Your Ref	SSD-53338465
Our Ref	NCA/2/2023
Contact	Paul Sartor
Telephone	9806 5740
Email	psartor@cityofparramatta.nsw.gov.au

COUNCIL SUBMISSION

NOTICE OF EXHIBITION OF ENVIRONMENTAL IMPACT STATEMENT FOR THE GRAND AVENUE DATA CENTRE EXPANSION, ROSEHILL (8 GRAND AVENUE, ROSEHILL)

Landscape

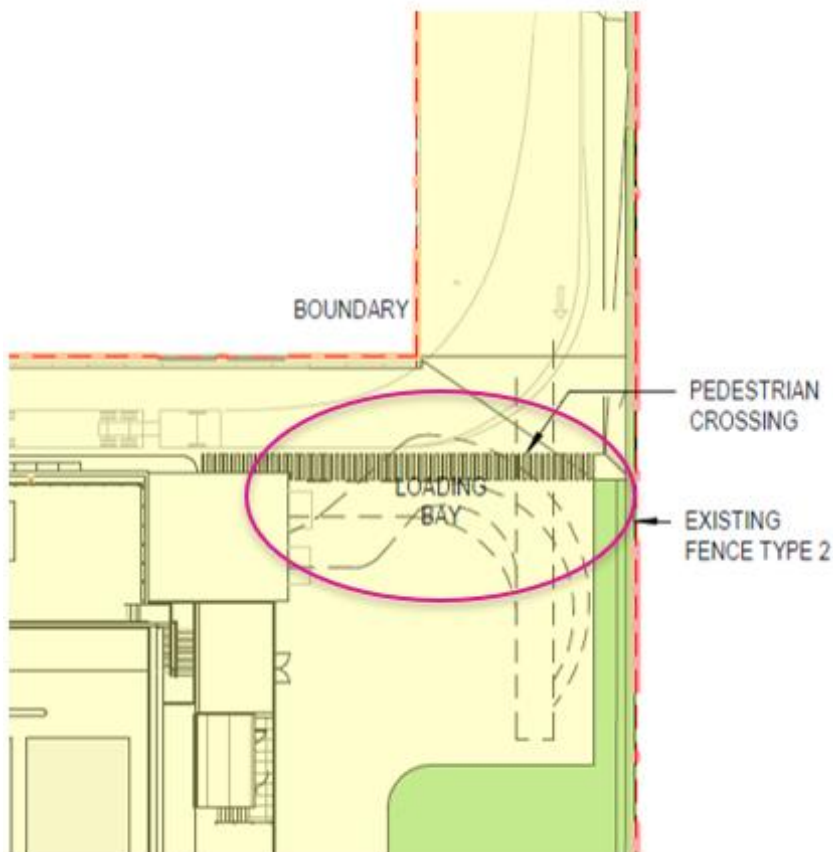
1. The landscape area is grossly inadequate across the Stage 2 development 4.8% and needs to be increased.
2. The deepsoil zone is inadequate across the site due predominantly to the parking areas and associated long driveway hard standing areas.
3. The proposed tree species are small/medium-sized trees and are recommended to be changed to larger canopy trees as there is plenty of room available for them to grow. Suggested species include:
 - *Corymbia eximia* (Yellow Bloodwood)
 - *Eucalyptus crebra* (Narrow-leaved Ironbark)
 - *Eucalyptus sideroxylon* (Mugga Mugga)
 - *Flindersia australis* (Crow's Ash)
 - *Corymbia maculata* (Spotted Gum)
 - *Syncarpia glomulifera* (Turpentine)

Note: The signature tree on the Landscape cover shows a Corymbia maculata but is not used in the scheme, this should be amended on the plans to be included.
4. In addition to the screen hedge planting proposed within the 2.5m landscape setback areas to the southern and western boundaries, additional medium-sized replacement trees are recommended to be planted along here at minimum 6m centres.
